MaineDOT Virtual Public Involvement Comment Summary

Project Name: Berwick, Route 9/Saw Mill Hill & School Street Intersection Improvements

WIN: 024647.00

Description: The project includes a re-configuration of this intersection to improve the safety of motorists, bicyclists, and pedestrians in this area.

The plan below shows the proposed new sidewalk in red, proposed future sidewalk extension in blue, and the proposed crosswalk in orange

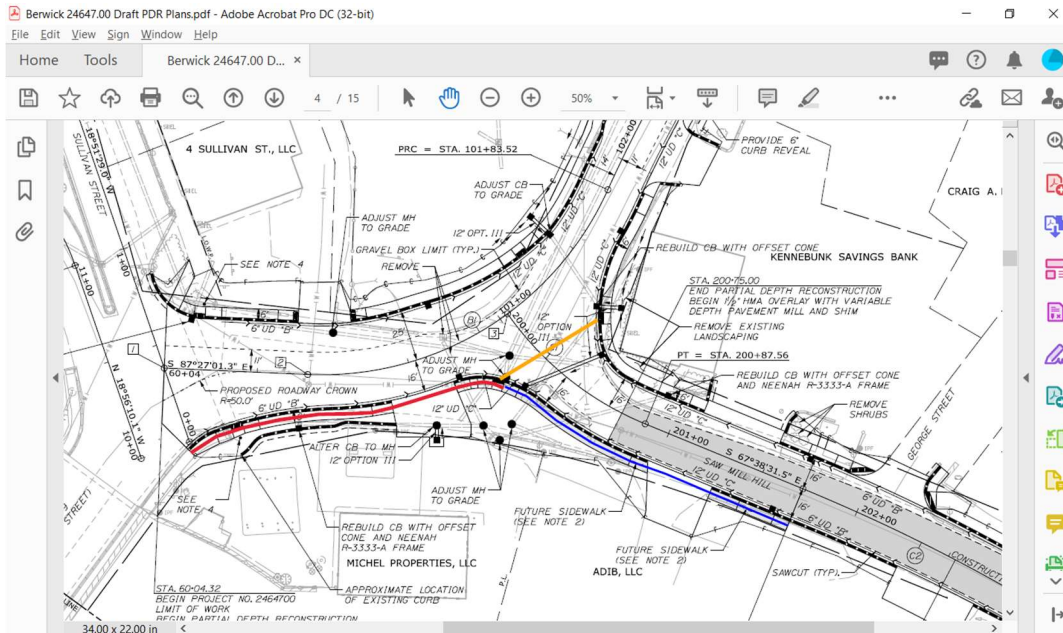
Date: 07/15/2021
Level of Support: Neutral
Response Requested: Respond to me by e-mail
Topic(s): Bike and pedestrian accommodations
Comment: Seems like the right time to include a sidewalk on the south side of the Saw Mill Hill intersection--hope that will be seriously considered.

Thank you for your interest in this project and question regarding a sidewalk on the south side of Saw Mill Hill Road. The current design includes the reconstruction of the existing sidewalk from the end of

the bridge easterly to the new proposed crosswalk across Saw Mill Hill Road at its intersection with School Street. As our policy does not allow us to build a sidewalk that does not connect into an existing sidewalk or to a destination, the sidewalk ends at this crossing. However, this design does take into consideration the possibility of a sidewalk extension along the south side of this road should there be a future project to construct a sidewalk to a destination such as Moulton street or beyond.
